CHANGE ORDER NO.: 1

Owner:	City of San Luis	Owner's Project No.:	2025-050
Engineer:	PACE	Engineer's Project No.:	B777
Contractor:	Filanc	Contractor's Project No.:	
Project:	West WWTP 3.0 MGD MBR Upgrades		
Contract Name:	West WWTP 3.0 MGD MBR Upgrades		
Date Issued:	June 24, 2026	Effective Date of Change Order:	June 24, 2026

CHANGE ORDER REQUEST

CHANGE ORDER TITLE: Potential Scope Adjustment Options

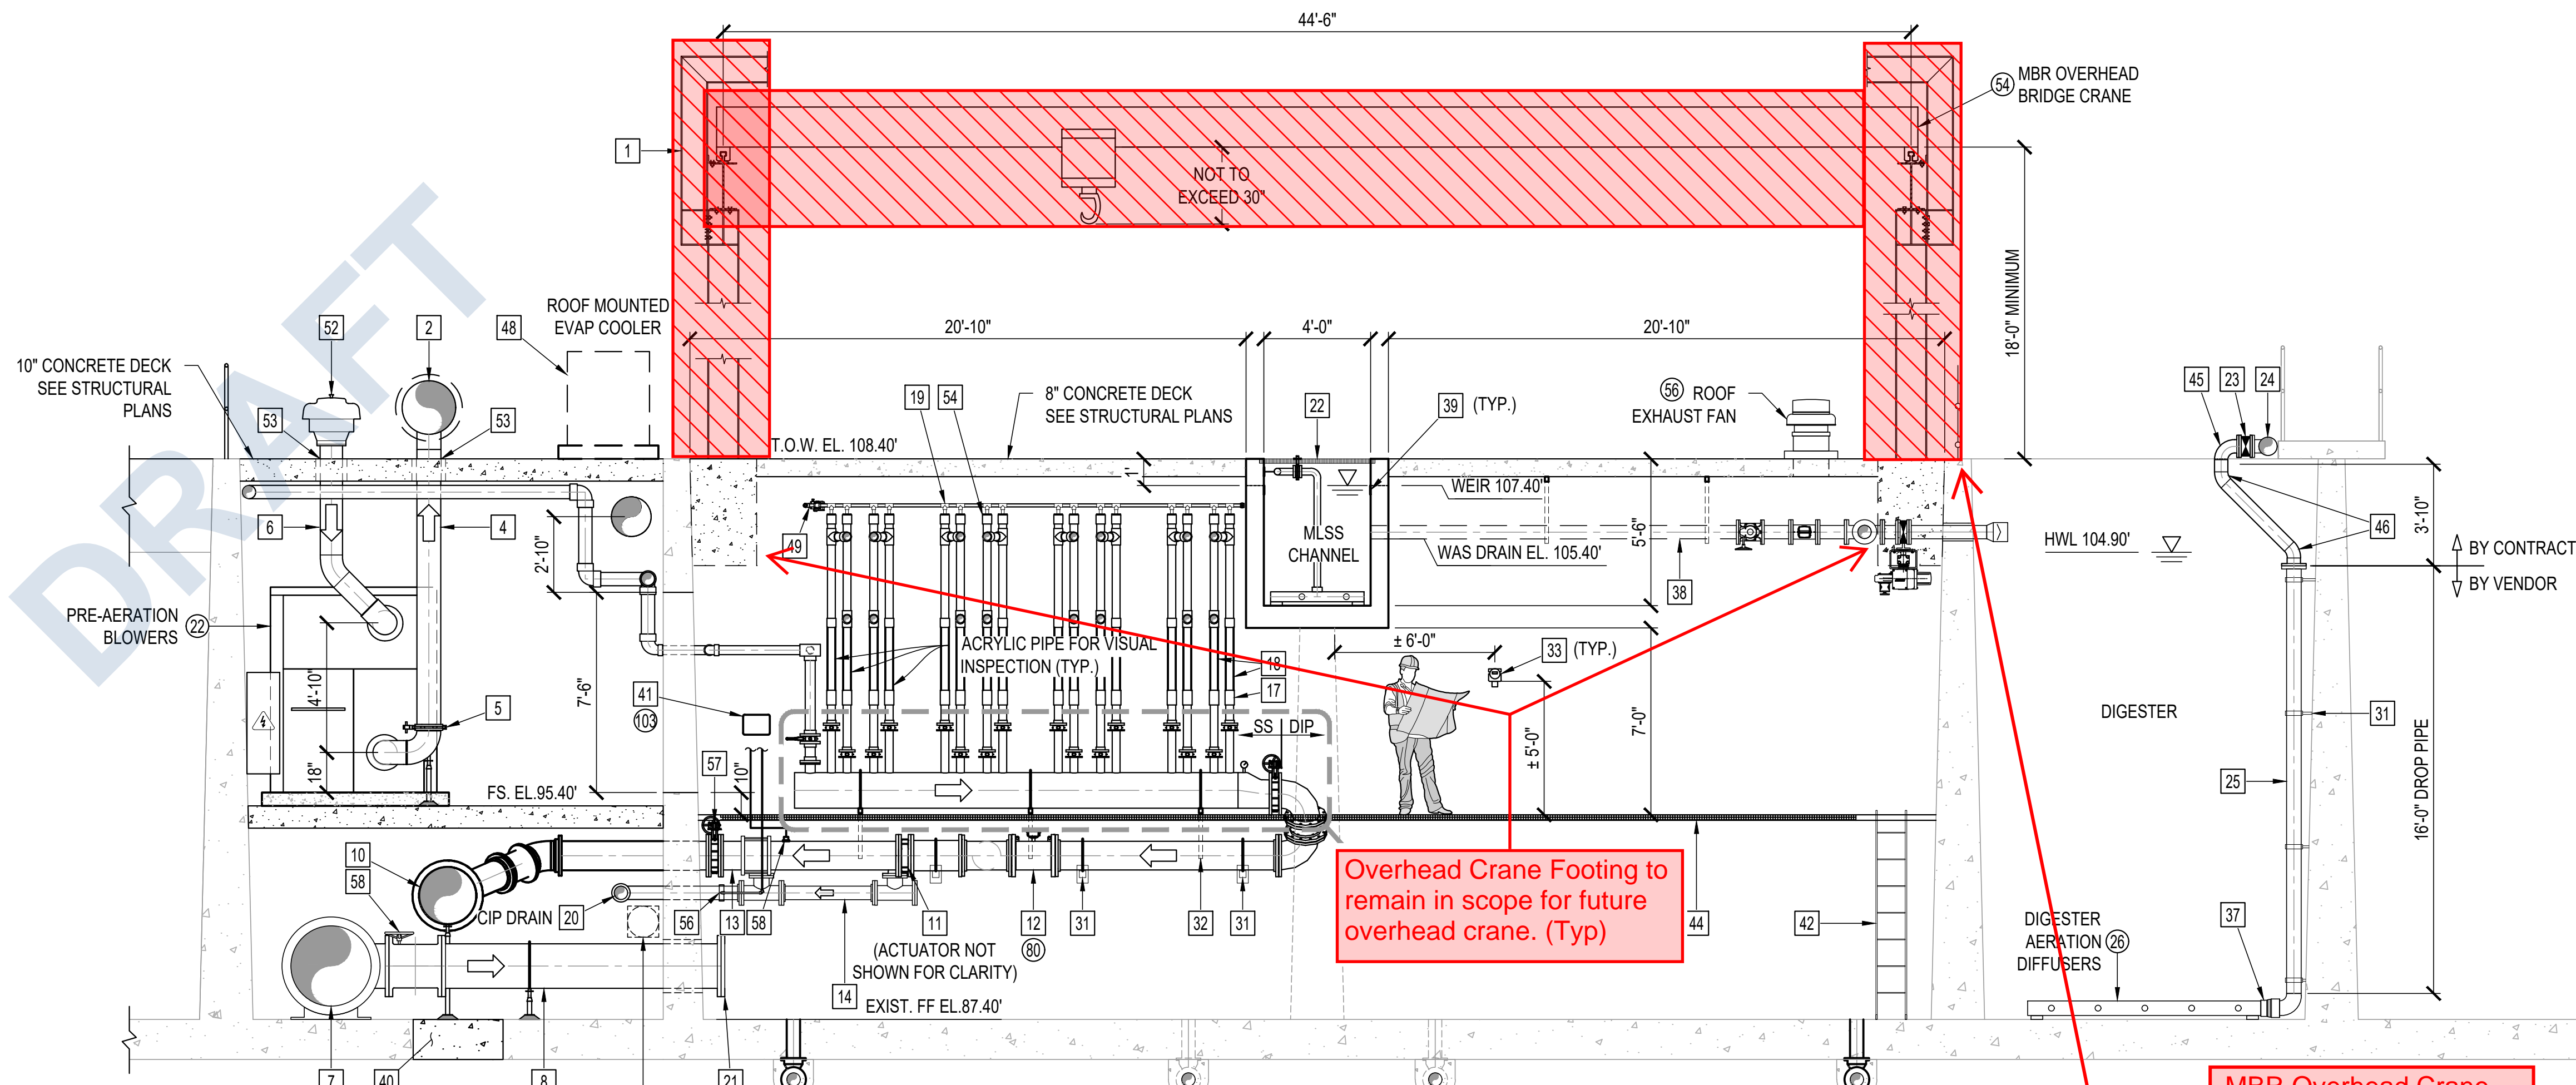
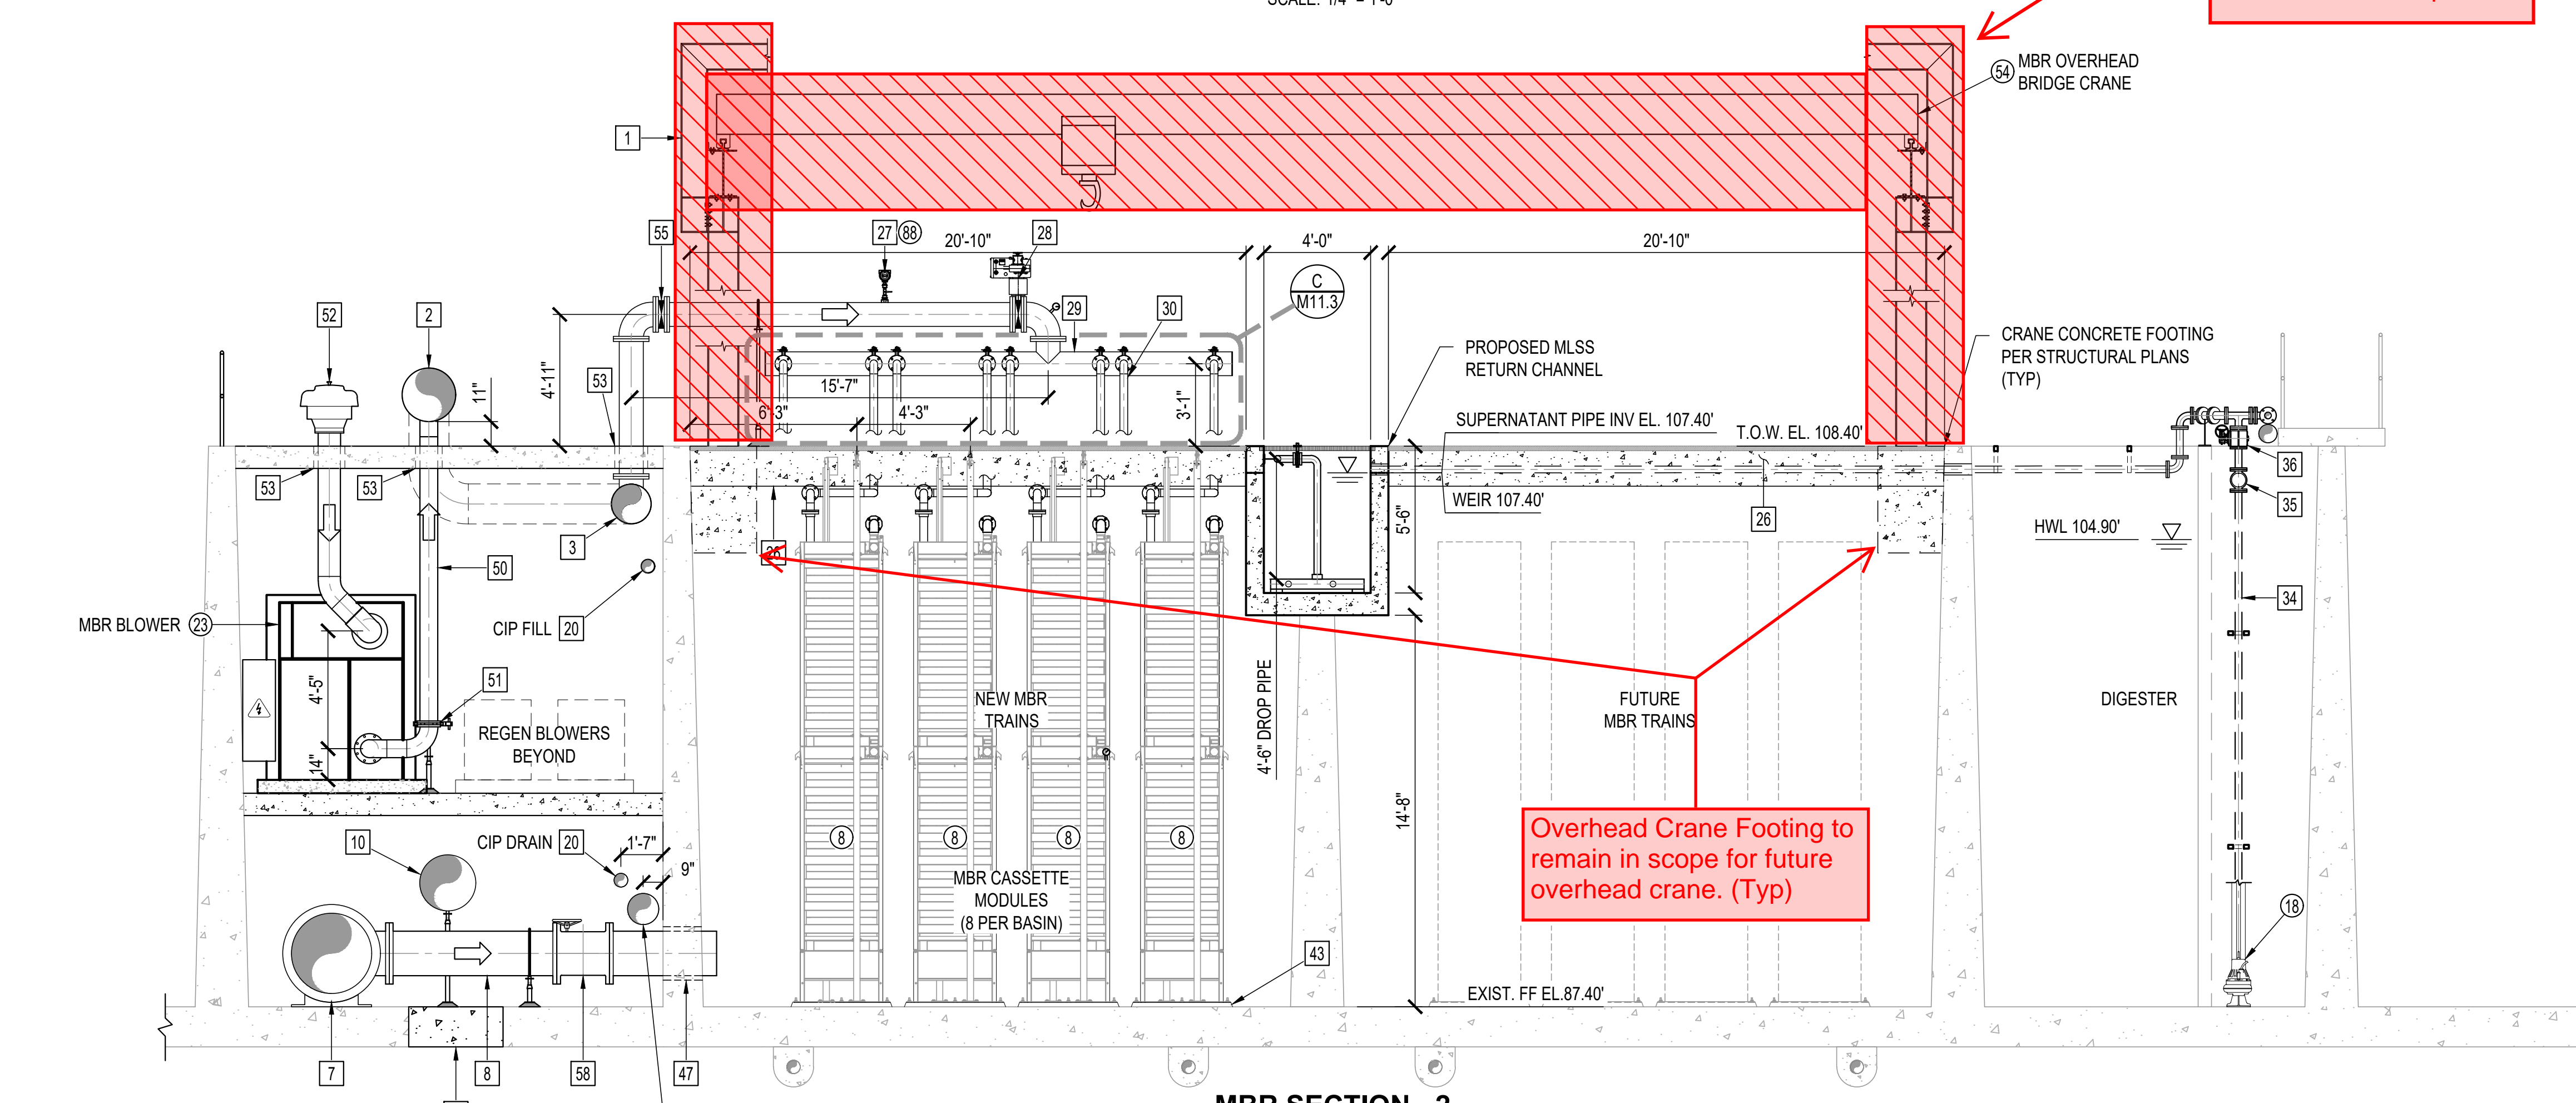
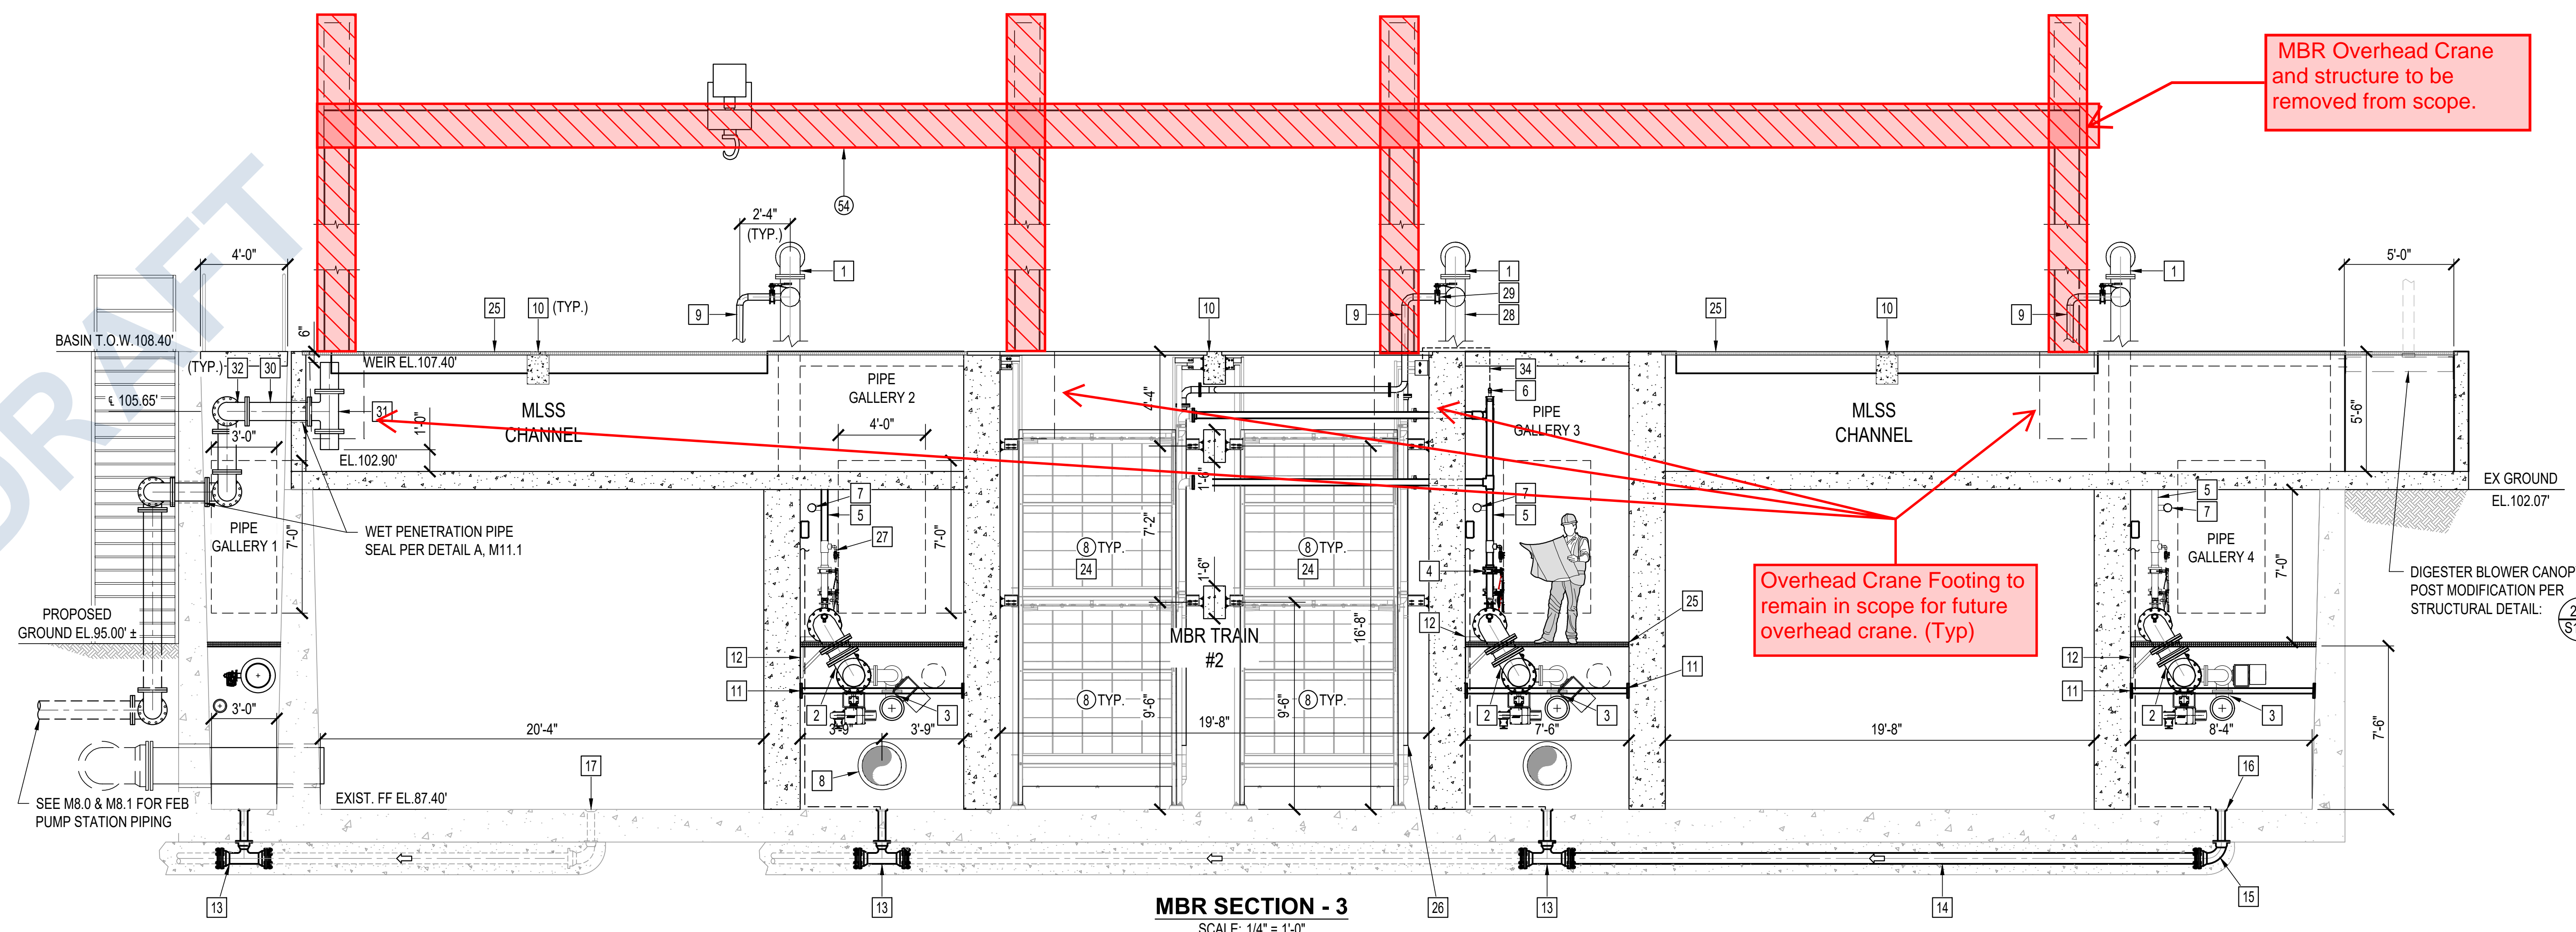
MBR Overhead Crane and structure to be removed from scope.

Overhead Crane Footing to remain in scope for future overhead crane. (Typ)

- Remove from scope: MBR FRP covers over the MBR basins shown on Sheet M2.0, Note 2.
- Remove from scope: MBR overhead crane structure shown on Sheet M2.3 (Note 1) and S2.2. Footing shall be provided as detailed in the structural plans for future overhead crane.
- Remove from scope: MBR overhead crane shown on Sheet M2.0 M2.3, M2.4
- Provide additional handrail in lieu of FRP covers at the MBR basins. Handrail to match other new handrailing provided in other areas as specified in project specifications and Sheet W11.0 Detail D.
- Remove from scope: Structural submittal requirements associated with the deleted structural scope items above.
